Technical News

Issue No.	Issue company	Issue Date (yyyy/mm/dd)	Revised Date (yyyy/mm/dd)	
PV21SEL-520	IPS(DI)	2021/12/21		
Subject				
Repair Parts Change Information				
Model	Destination	Country of origin	Serial number	Color
SEL2870	ALL	Thailand	~1049432	
		China	~4415089

INFORMATION

Replacing the CL-1020, COMPLETE PC BOARD

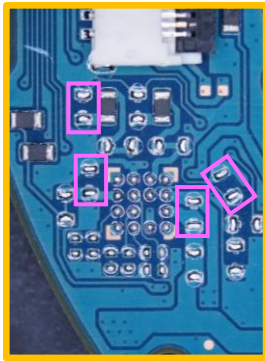
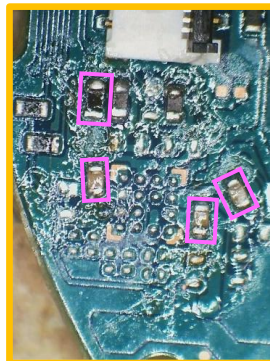
Check the printing of the square part of the CL-1020, COMPLETE PC BOARD photo.

Check for the presence of surface mount devices in the square area.

No surface mount devices in the square area

Surface mount devices are present in the square area

Both of A-2107-277-**A** CL-1020, COMPLETE PC BOARD(SERVICE)

A-2107-277-**B** CL-1020, COMPLETE PC BOARD(SERVICE)

Only A-2107-277-**B** CL-1020, COMPLETE PC BOARD(SERVICE) can be used for the replacement.

Replacing the SERVICE, FIXEDTUBE ASSY

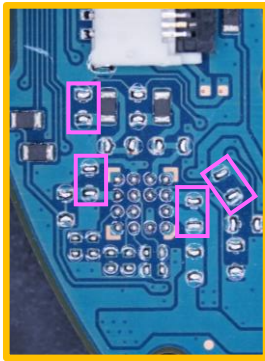
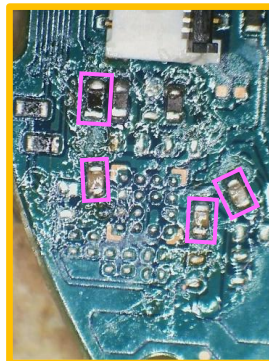
Check the printing of the square part of the CL-1020, COMPLETE PC BOARD photo.

Check for the presence of surface mount devices in the square area.

No surface mount devices in the square area

Surface mount devices are present in the square area

Only A-2107-273-A SERVICE, FIXEDTUBE ASSY needs to be replaced.
*Parts listed in the service manual

In addition to A-2107-273-A SERVICE, FIXEDTUBE ASSY
*Parts listed in the service manual,
A-2107-277-B CL-1020, COMPLETE PC BOARD(SERVICE) also needs to be replaced.

Replacing the LF-2069 FLEXIBLE PWB (CN9129)

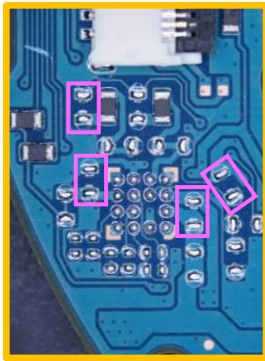
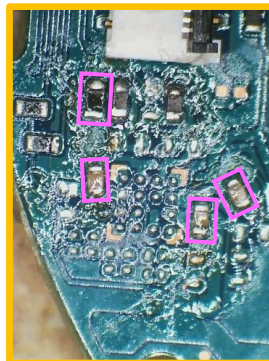
Check the printing of the square part of the CL-1020, COMPLETE PC BOARD photo.

Check for the presence of surface mount devices in the square area.

No surface mount devices in the square area

Surface mount devices are present in the square area

Only 1-889-221-12 LF-2069 FLEXIBLE PWB (CN9129) needs to be replaced.
*Parts listed in the service manual

In addition to 1-889-221-12 LF-2069 FLEXIBLE PWB (CN9129)
*Parts listed in the service manual, A-2107-277-B CL-1020, COMPLETE PC BOARD(SERVICE) also needs to be replaced.

Replacing the BL CONTACT ASSY

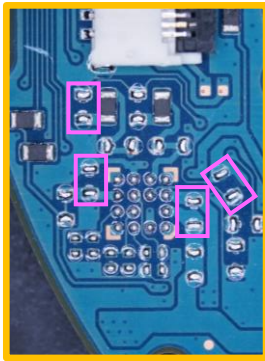
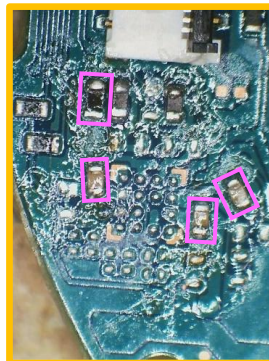
Check the printing of the square part of the CL-1020,
COMPLETE PC BOARD photo.

Check for the presence of surface
mount devices in the square area.

No surface mount devices
in the square area

Surface mount devices are
present in the square area

Only A-1966-719-A BL CONTACT ASSY
needs to be replaced.

In addition to A-1966-719-A BL CONTACT
ASSY

*Parts listed in the service manual,
A-2107-277-B CL-1020, COMPLETE PC
BOARD(SERVICE) also needs to be replaced.

Replacing the MOUNT ASSY

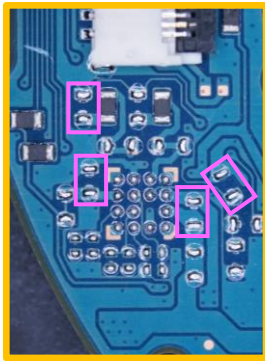
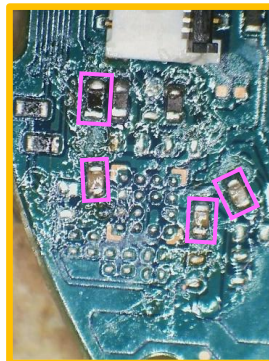
Check the printing of the square part of the CL-1020,
COMPLETE PC BOARD photo.

Check for the presence of surface
mount devices in the square area.

No surface mount devices
in the square area

Surface mount devices are
present in the square area

Only A-1992-167-A MOUNT ASSY needs to
be replaced.

In addition to A-1992-167-A MOUNT ASSY

*Parts listed in the service manual,
A-2107-277-B CL-1020, COMPLETE PC
BOARD(SERVICE) also needs to be replaced.
